February 22, 2024

Re: Concern Regarding Proposed Septic System on Carleton Island in the St. Lawrence River, Town of Cape Vincent, Jefferson County

CARLETON VILLA

SITEPLAN

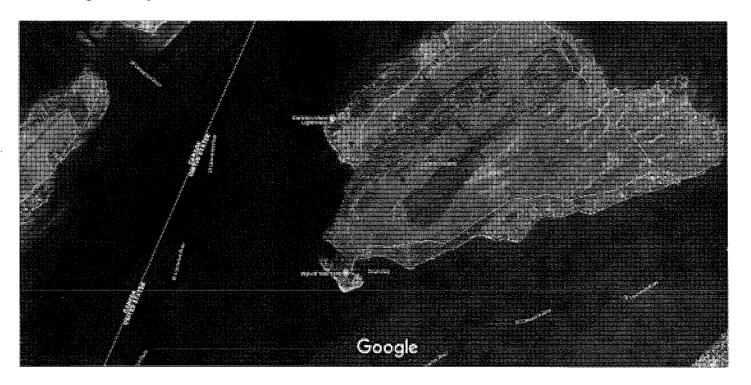
As can be seen from the first photo, most of the proposed campground would be located on a roughly 400 foot by 500 foot rectangular parcel (the "Neck") which connects the peninsula at the western end of Carleton Island (the "Head") to the main body of the Island lying to the east (the "Body"). The Neck is bordered on the north and south by the shorelines of two bays known as North Bay and South Bay.

Carleton Island residents are concerned that any below ground septic system for the proposed campground would likely contaminate groundwater and North and South Bays. We hope that the Department would not grant a permit to such a system that did

not strictly adhere to the state sanitary code rules and regulations provided in Appendix 75-A. If the new septic system cannot meet the required horizontal and vertical separation distances, we ask that no variance or Specific Waiver is issued for the project. We understand that these separation distances have been established to protect human health and the environment. We note that the campground environment is particularly vulnerable because the campground is near fresh water, low lying and subject to shoreline flooding.
